INFORMATION LETTER 206L-00-70

TO: All Owners/Operators of Bell 206L, L-1 and L-3 Helicopters.

SUBJECT: LOW CLEARANCE BETWEEN HYDRAULIC RETURN TUBE ASSEMBLY 206-076-649-101 AND CYCLIC CONTROL TUBE ASSEMBLY 206-001-193-001.

FIGURE 1.

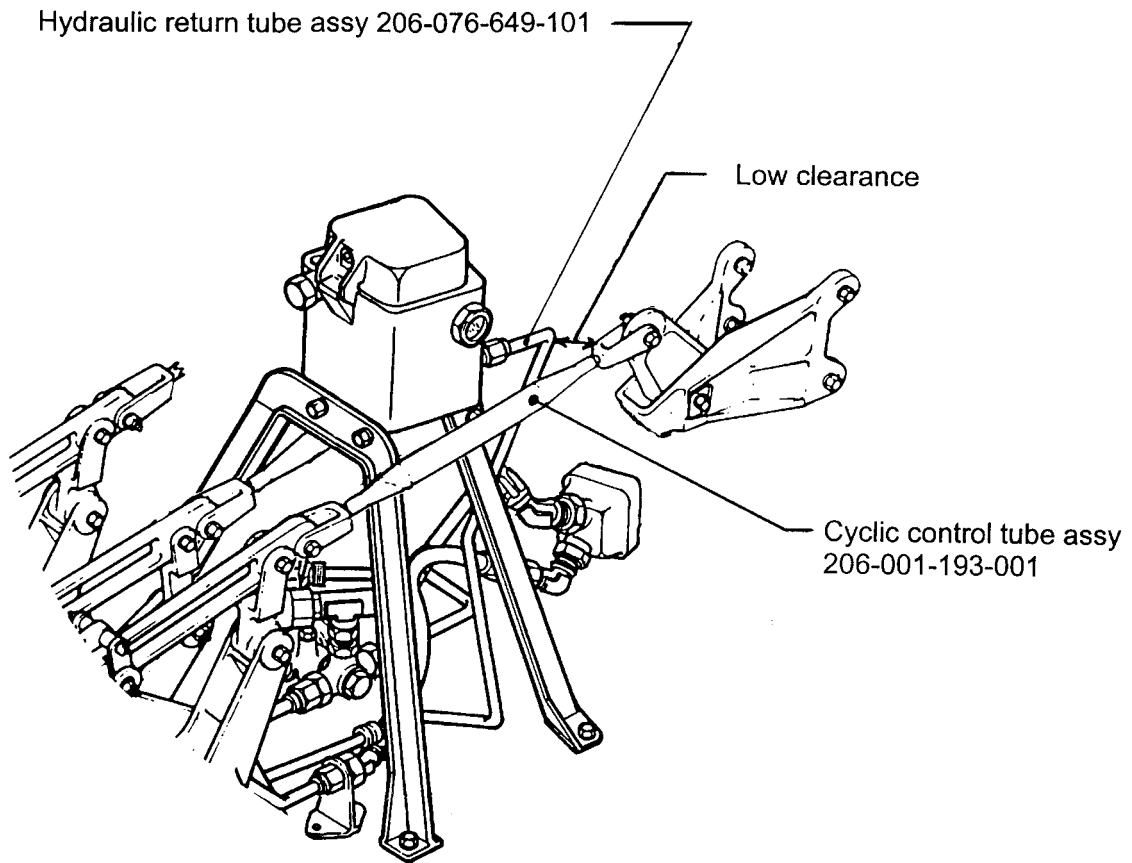
In low clearance conditions, the aft clevis of the left hand cyclic control tube assembly 206-001-193-001 may contact the hydraulic return tube assembly in the area of the uppermost bend, see figure 1. The contact will be evidenced by chafing marks on the hydraulic tube assembly 206-076-649-101.

A tube assembly 206-076-665-101 has been developed with increased clearance, and introduced on the model 206L4. In order to correct or prevent a low clearance condition, tube assembly 206-076-649-101 may be replaced with tube assembly 206-076-665-101 which provides more clearance in that location. Tube assembly 206-076-665-101 supersedes tube assembly 206-076-649-101.
